LEHIGH INDUSTRIAL PARK Inactive Hazardous Waste Site

Lackawanna (C), Erie County, New York
Site No. 9-15-145

RECORD OF DECISION

RESPONSIVENESS SUMMARY
for the
PROPOSED REMEDIAL ACTION PLAN

Figure 5

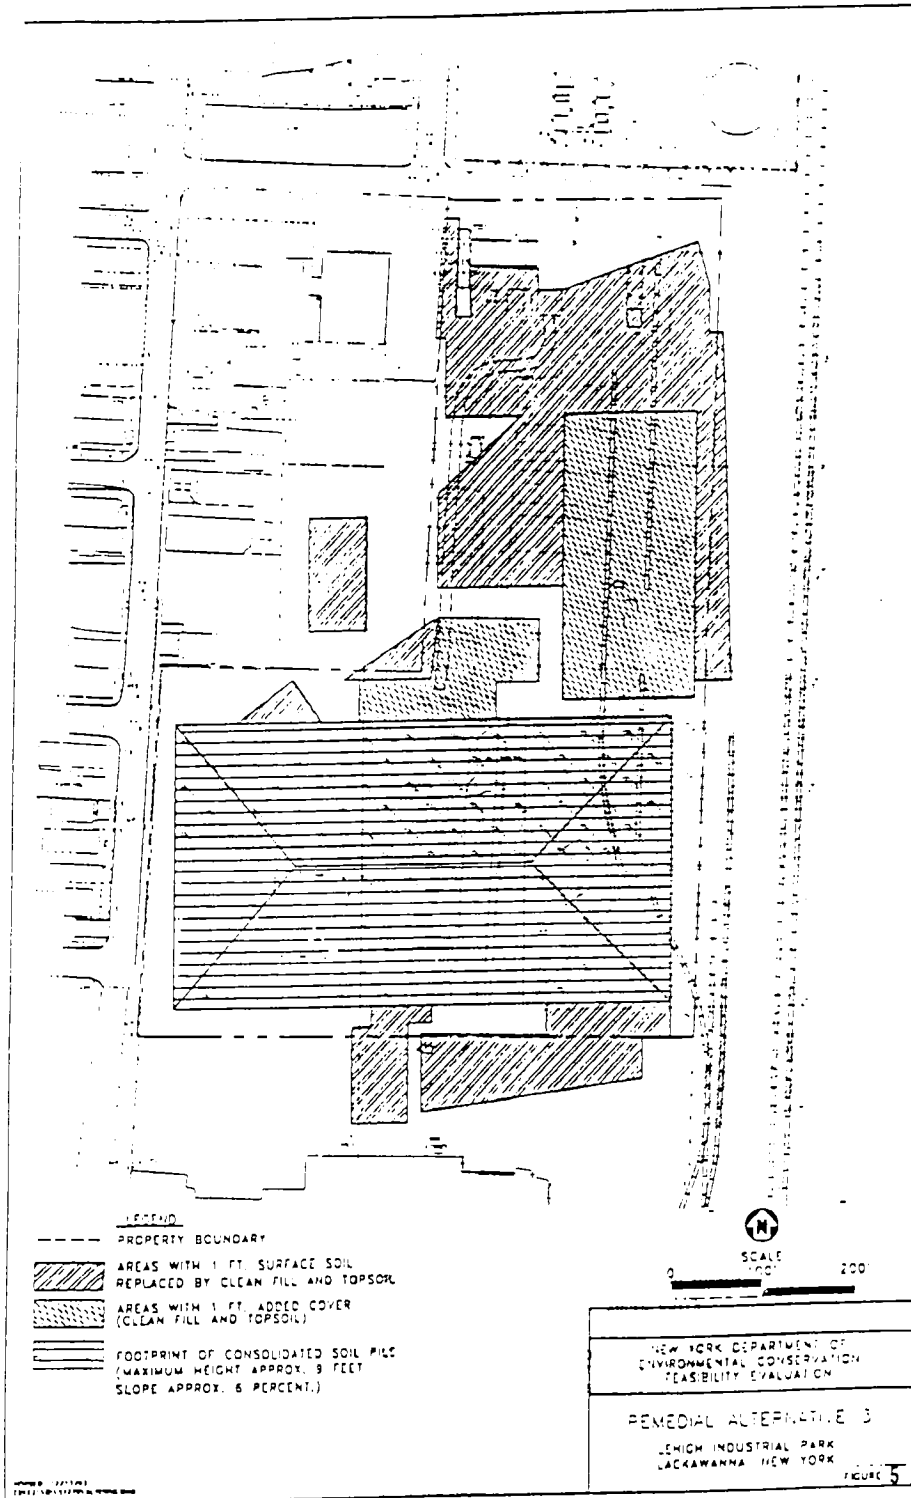
COMMENT #3: In the capped area, what will the height be above the current ground surface?

COMMENT #15: The area which will be capped will be a nine foot tall mound. How can you make a baseball or a soccer field or anything out of it if it will be shaped like a pyramid? Are capping it and the nine foot tall mound two different options?

RESPONSE #3: In the conceptual plan presented as Figure 5 of the ROD, the proposed configuration would result in a mounded area of about four acres with a maximum height of about nine (9) feet above the existing ground surface. However, as noted at the meeting, flexibility in designing this capped area exists which could result in a lower capped height but possibly over a larger area, dependent on any beneficial reuse which may ultimately be considered for the site.

RESPONSE #15: Whether the final shape is a pyramid or a recreational field, the site will be capped. The mound shape proposed as a conceptual plan for the cap is one option, other configurations are possible provided they can achieve the design specifications of the cap itself.
